2.2 Control and Instrument Systems

The information in this section of the reference ABWR DCD, including all subsections, tables, and figures, is incorporated by reference with the following departures.

Figure 2.2.1 Rod Control and Information System Control Interface Diagram

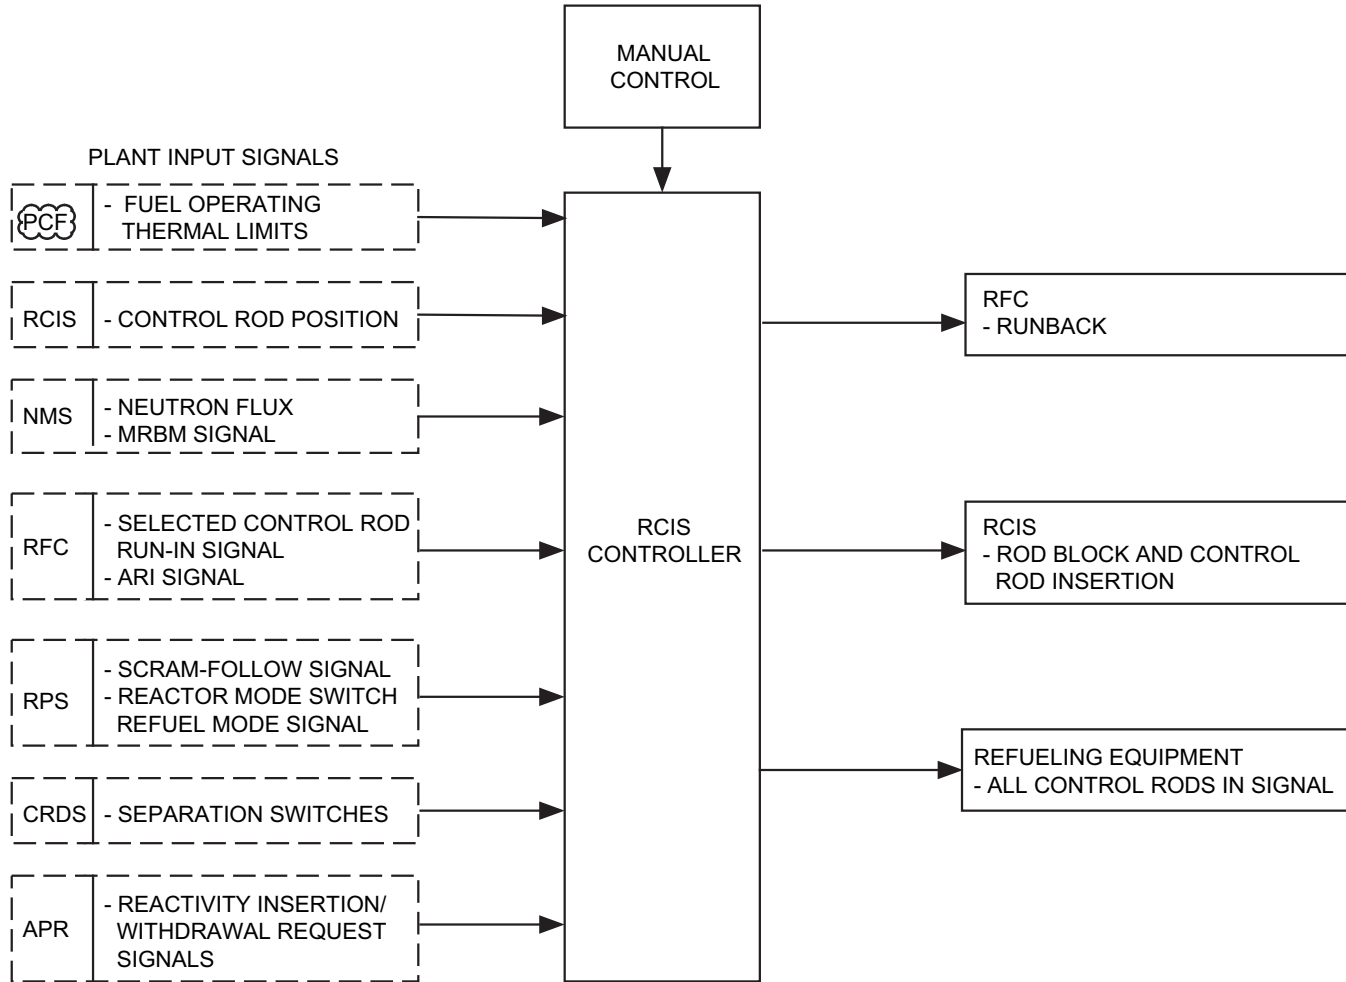
STD DEP T1 3.4-1 (Figure 2.2.1)

NOTE:
1. INTERCONNECTIONS MAY BE FIBER-OPTIC OR METALLIC.

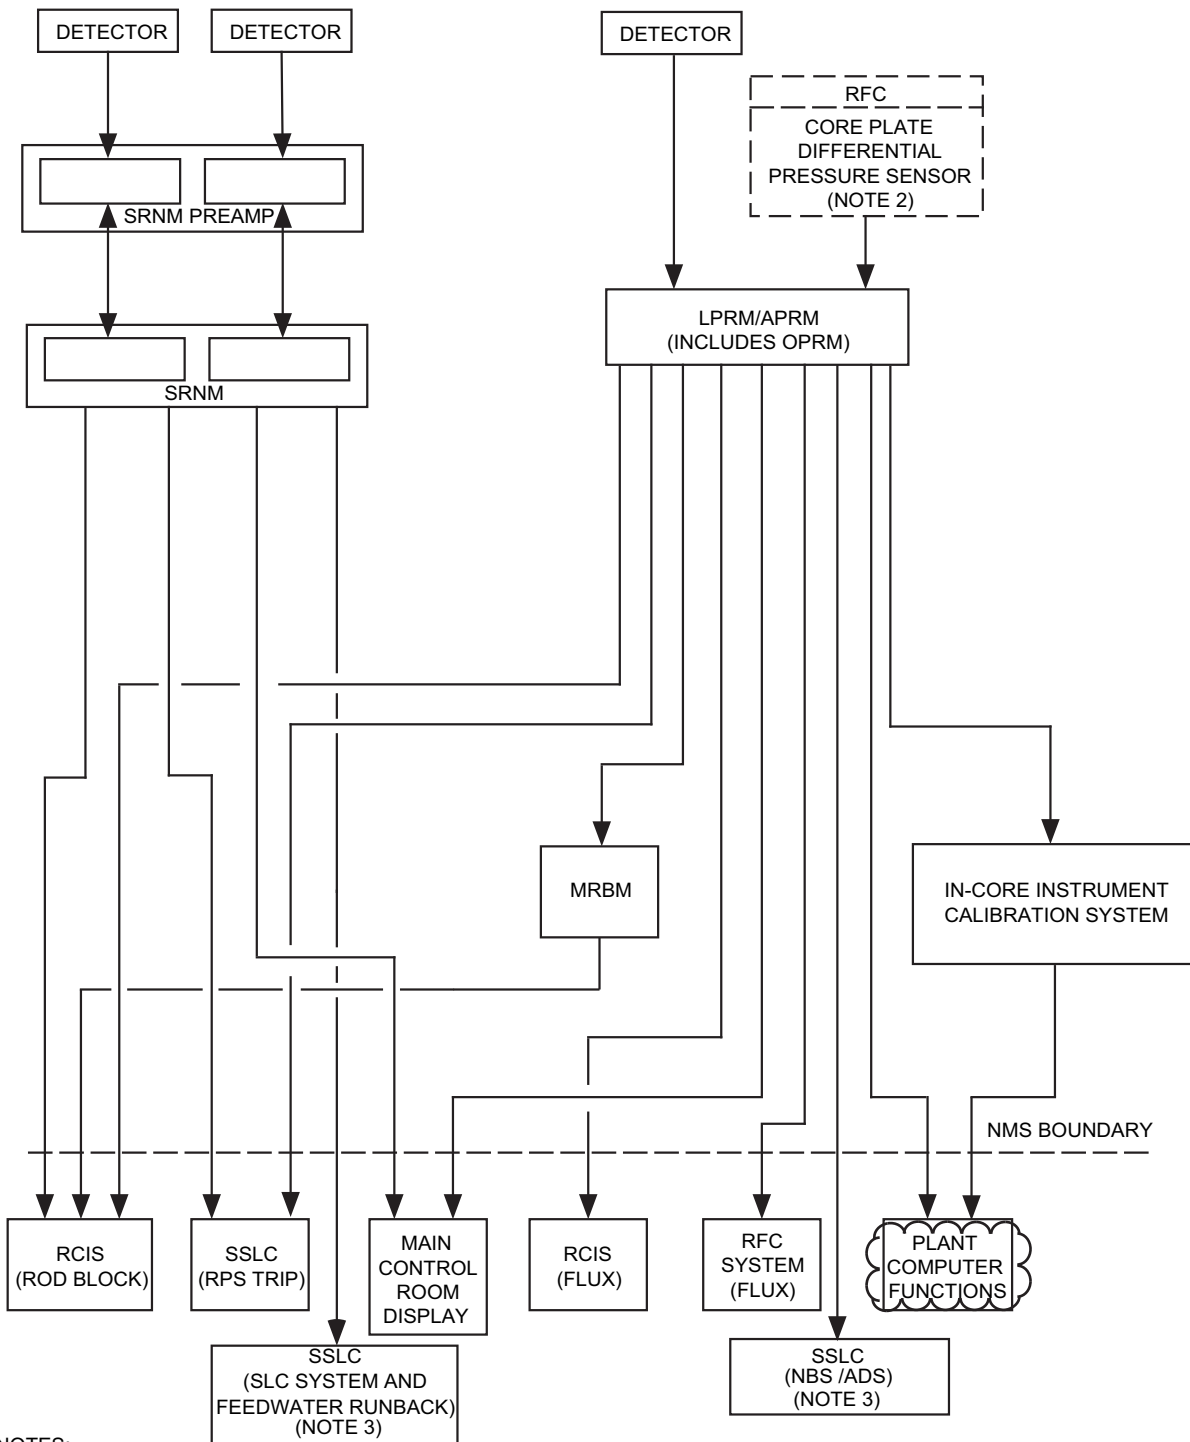
The FDWC digital controllers determine narrow range level signal using three reactor level measurement inputs from the NBS. ~~Sensor signals are transmitted to the FDWC digital controllers by the Non-Essential Multiplexing System (NEMS).~~

The steam flow in each of four main steamlines is sensed at the RPV nozzle venturis. ~~Sensor signals are transmitted to the FDWC System digital controllers by the NEMS.~~ These measurements are processed in the digital controllers to calculate the total steam flow out of the vessel.

Feedwater flow is sensed at a flow element in each of the two feedwater lines. ~~Sensor signals are transmitted to the FDWC digital controllers by the NEMS.~~ These measurements are processed in the digital controllers to calculate the total feedwater flow into the vessel.

Figure 2.2.7b Reactor Protection System

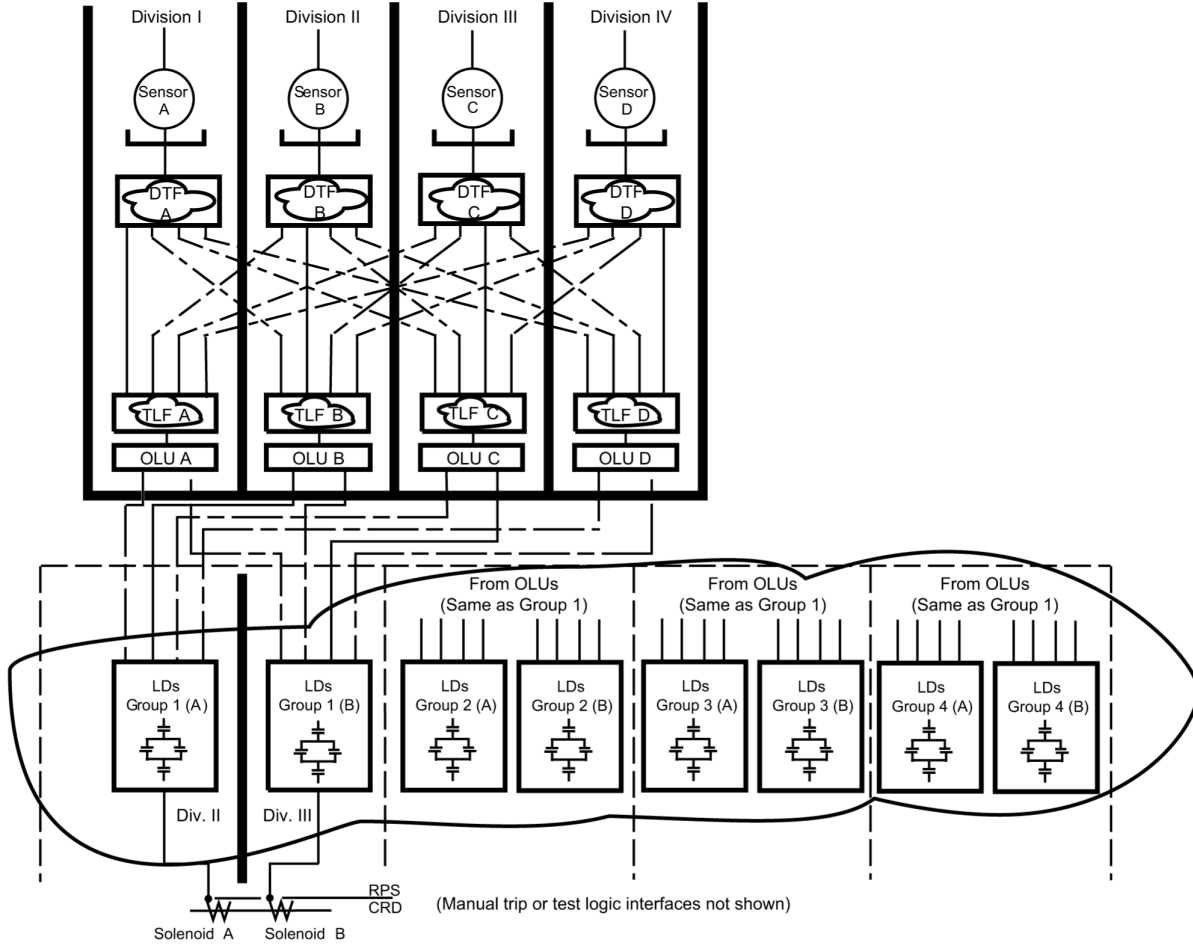
STD DEP T1 3.4-1 (Figure 2.2.7b)

The RPS has four divisions. Figure ~~2.2.6a~~ 2.2.7b shows the RPS divisional aspects and the signal flow paths from sensors to scram pilot valve solenoids. Functions Equipment within an RPS division consists of include sensors (transducers or switches), I/O, ~~multiplexers~~, data communication, digital trip ~~modules~~ functions (DTM DTF), trip logic ~~unit function~~ (TLU TLF), output logic unit (OLU), and load drivers (LD). The LDs are only in Divisions II and III. The (DTF) and (TLF) are performed in digital configurable logic devices. The data communication functions are described in Section 2.7.5.

The RPS consists of logic and circuitry for initiation of both automatic and manual scrams. The automatic scram function is ~~comprised of~~ accomplished redundantly in four independent divisions of sensor instrument channels, hardware/software based logic and logic processing, and two independent divisions of actuating devices. Automatic scram is initiated whenever a scram condition is detected by two or more automatic divisions of RPS logic. ~~For automatic scram, the sensor input signals to the RPS originate either from the RPS's own sensors or other systems' sensors. For determination of the existence of an automatic scram condition, within each automatic scram channel division of the RPS, the DTM DTF of a given RPS channel division compares the monitored process variable with the a stored setpoint stored in its memory and issues a trip signal if the monitored process variable exceeds the setpoint. The DTM DTF then sends the trip signal to the TLU TLF of its own channel division and the TLU TLFs of the other three channels divisions of RPS, where two-out-of-four voting is performed (see Figure 2.2.6a). The TLF in each division performs an independent two-out-of-four vote on each RPS DTF input.~~

~~In the case of high suppression pool average temperature trip and inboard/outboard MSIV closure signals, the SPTM module of SSLC and NBS provide their divisional trip signals directly to the corresponding divisional RPS DTM. However, In the case of the NMS, the four channels divisions of the NMS each provide their trip signals to each RPS divisional TLU TLF. A list of conditions that can cause automatic reactor scram is provided below. The name of the system that provides the sensor input signal or the trip signal is shown in brackets.~~

- (3) NMS Trips [~~Discrete trip signals to RPS TLUs~~ NMS]

- (7) *Main Steamline Isolation [~~NBS discrete signals to RPS DTMs~~]*
- (9) *High Suppression Pool Average Temperature [~~SPTM Module of SSLC trip signals to RPS DTMs~~]*

The ~~TLU~~ TLFs provide their trip signals to their divisional OLU which ~~are used to~~ control the solid-state LDs that control the Class 1E AC power to the scram solenoids, and relays that control DC power to back-up scram valves. For automatic scram initiation, the ~~TLU~~ TLF trip signals cause the LDs to interrupt Class 1E AC power to the scram solenoids (fail-safe logic), cause the back-up scram relays to supply DC power to back-up scram solenoids, and provide scram follow signals to the RCIS. Each division of RPS controls eight LDs. The LDs are arranged to switch AC power to the scram solenoids in a two-out-of-four ~~format arrangement~~. That is, reactor scram will occur only if two or more divisions of the RPS provide trip signals to their associated LDs and both scram solenoids are de-energized.
